PLANNING AND ZONING COMMISSION
CITY OF BETTENDORF
FEBRUARY 15, 2023 AT 5:30 PM
CITY HALL COUNCIL CHAMBERS
1609 STATE STREET

Request: Lot 3, Bettendorf Industrial Park 5th Addition – Site Development Plan

Request: Major Change to an existing Site Development Plan (SDP)

Request: Major Change to an existing Site Development Plan (SDP) Location: 3150 Glenbrook Circle South and adjacent properties

- (A) Aerial Map
- (B) Zoning Map
- (C) Future Land Use Map
- (D) Final Plat Glenbrook Ridge 3rd Addition
- (E) 3150 Glenbrook Circle South Current SDP
- (F) 3150 Glenbrook Circle South Proposed Major Change to SDP
- (G) Response to staff comments

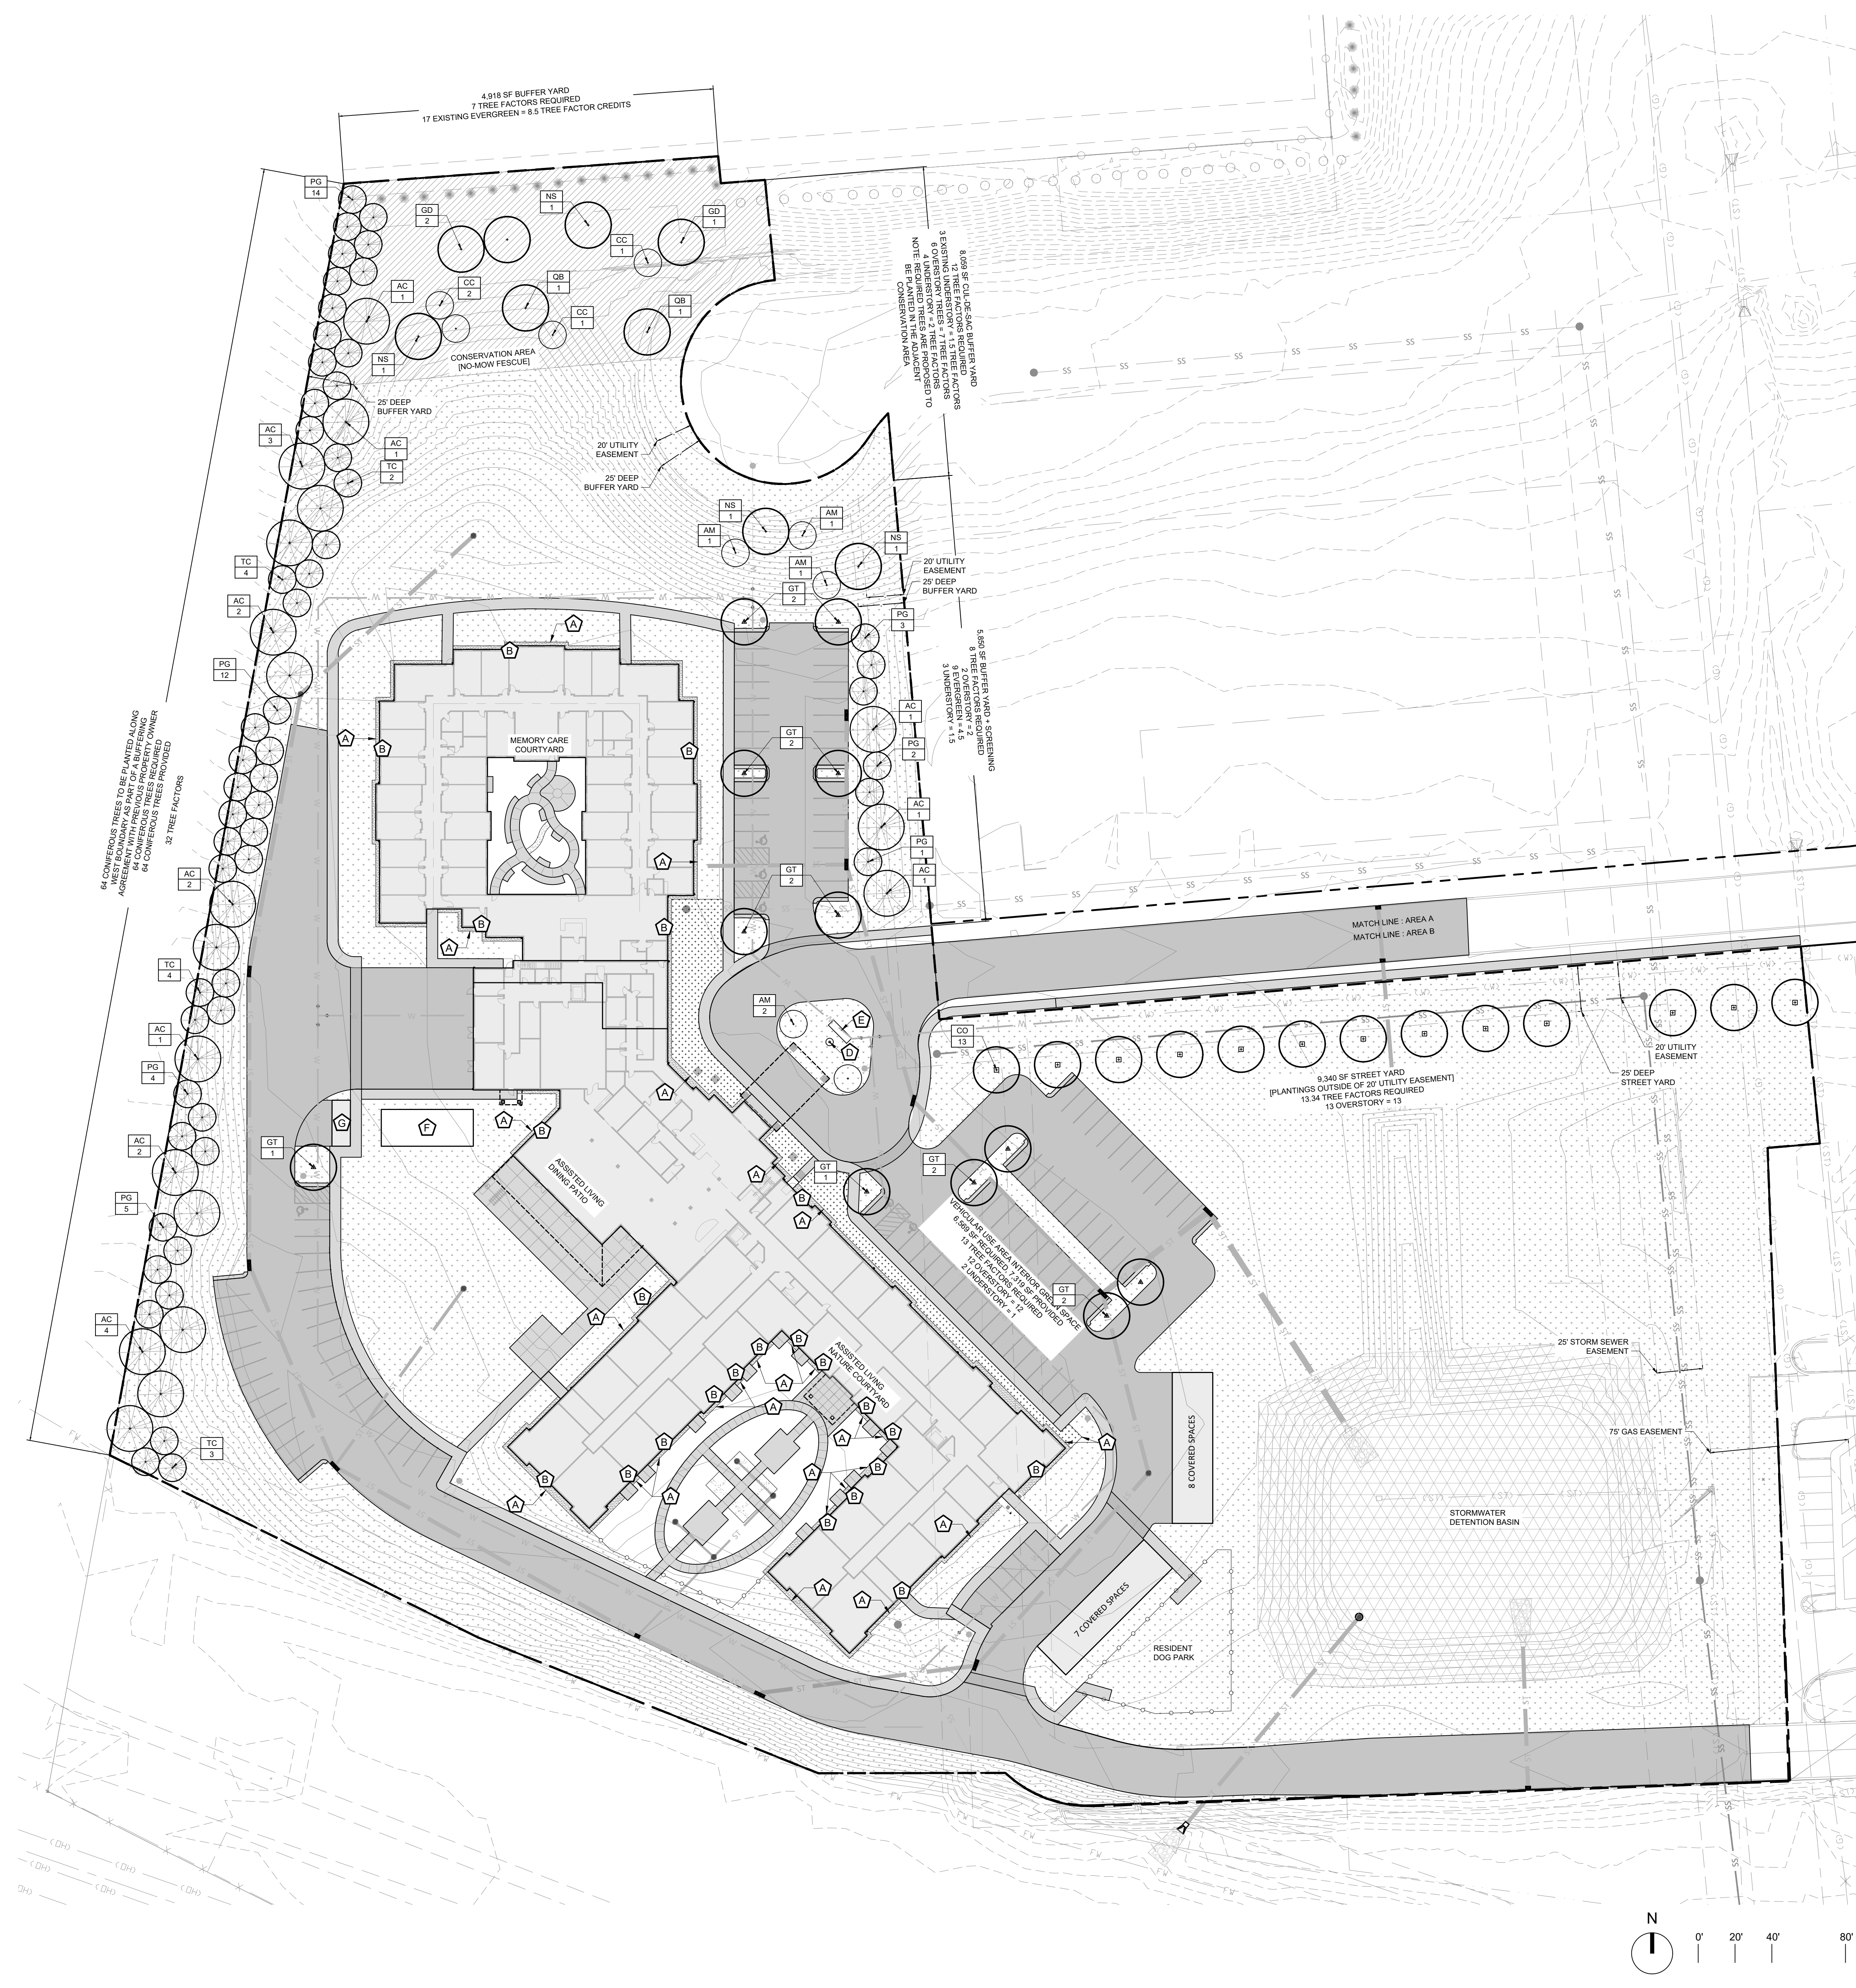
The approved Quartet SDP shows approximately 486 feet of frontage along Glenbrook Circle South matched to a lot width of roughly 486 feet. The proposed Major Change to the Quartet SDP reduces the frontage along Glenbrook Circle South to approximately 165 feet, while the lot width remains 486 feet. The proposed Major Change does not meet this criterion.

Staff contends the open space/drainage area is integral the Quartet's SDP and the Glenbrook Ridge DCA. The proposed Major Change appears to eliminate multiple trees from the Landscape Plan originally approved with the SDP. It also appears to remove buffering/transitioning, between the Quartet and the nearby townhomes and apartments. Changes to the existing drainage pattern would occur. The proposed Major Change does not meet this criterion.

The ability of the developer to provide the dog park as shown and required under the current SDP is severely limited by the proposed Major Change. Staff finds this to have a negative impact on the proposed Major Change.

The drainage area's pond and open space was a major focal point of the landscape aesthetic of the approved SDP. Removing this from the landscape has a significant impact to the look and feel of the built environment within the Glenbrook Ridge DCA. Staff finds this to have a negative impact on the proposed Major Change.

REVISED SITE PLAN WITH BOTH BUILDINGS

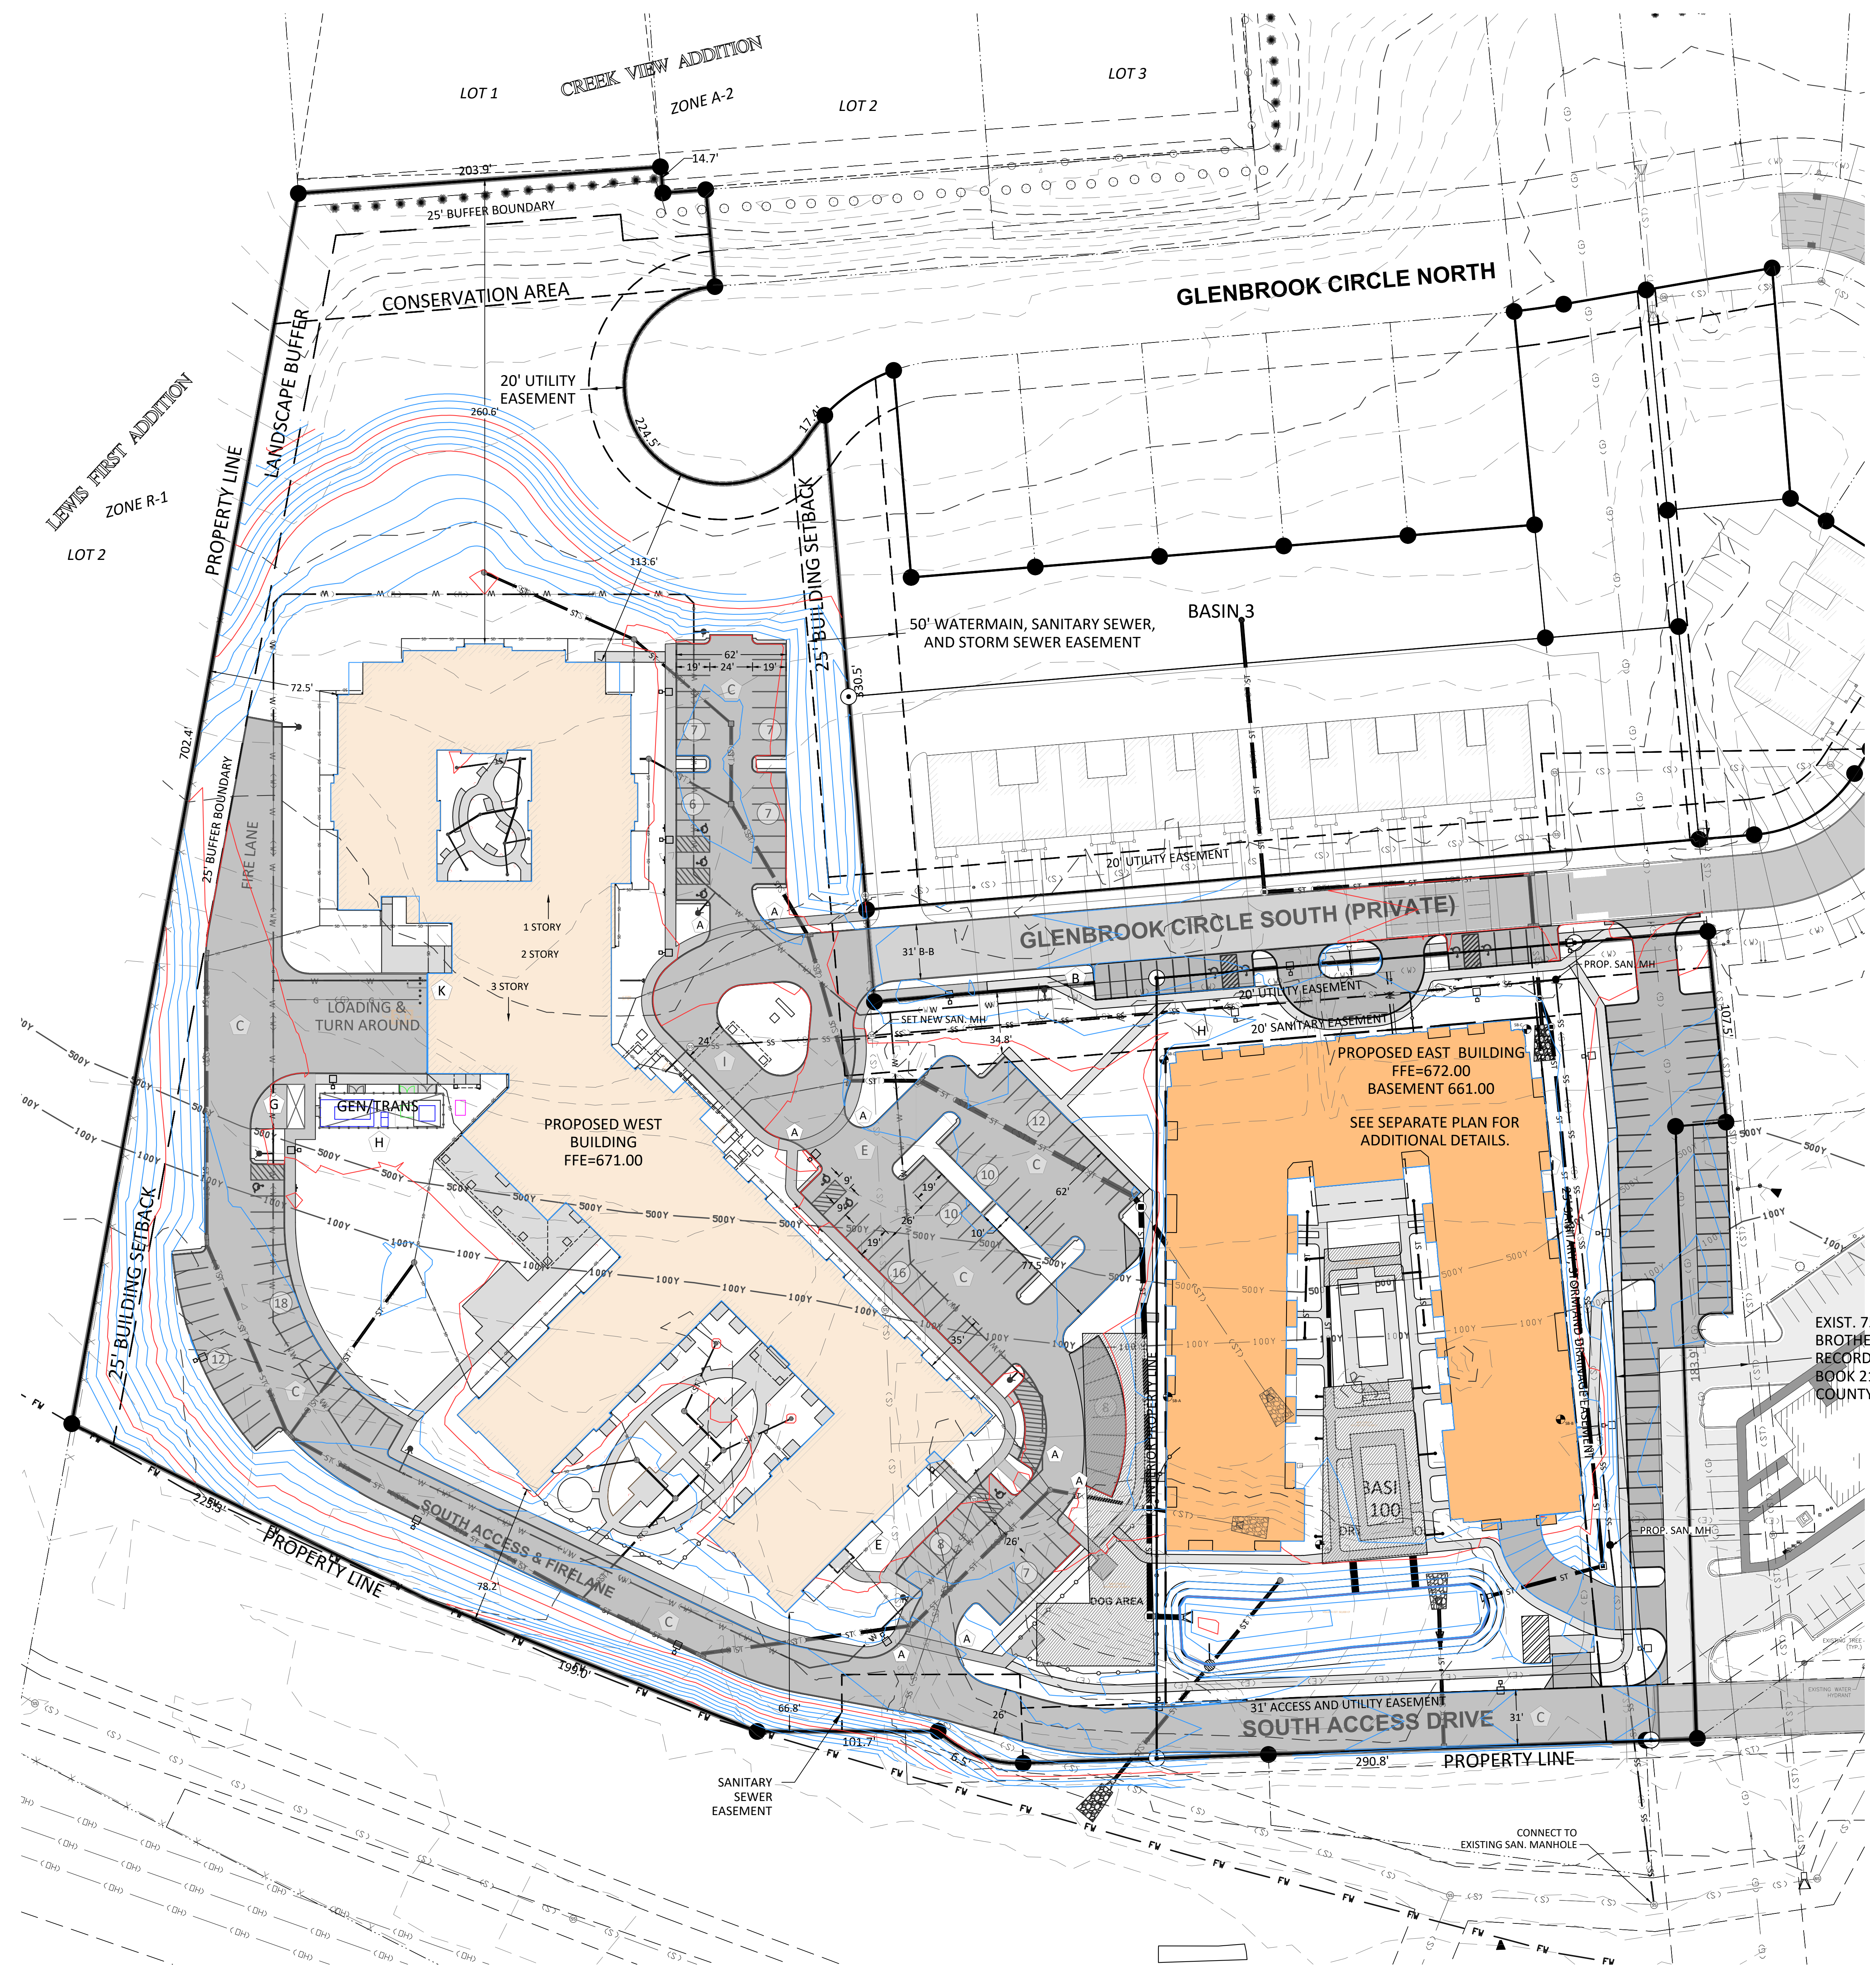
approximately 486 feet of frontage along Glenbrook Circle South matched to a lot width of roughly 486 feet. The proposed Major Change to the Quartet SDP reduces the frontage along Glenbrook Circle South to approximately 165 feet, while the lot width remains 486 feet. The proposed Major Change does not meet this criterion.

Staff contends the open space/drainage area is integral the Quartet's SDP and the Glenbrook Ridge DCA. The proposed Major Change appears to eliminate multiple trees from the Landscape Plan originally approved with the SDP. It also appears to remove buffering/transitioning, between the Quartet and the nearby townhomes and apartments. Changes to the existing drainage pattern would occur. The proposed Major Change does not meet this criterion.

AS NOTED, THE REVISED SITE PLAN STILL MEETS CITY CODE AS IT RELATES TO DENSITY AND UNITS PER ACRE FOR THE UMI DCA USE.
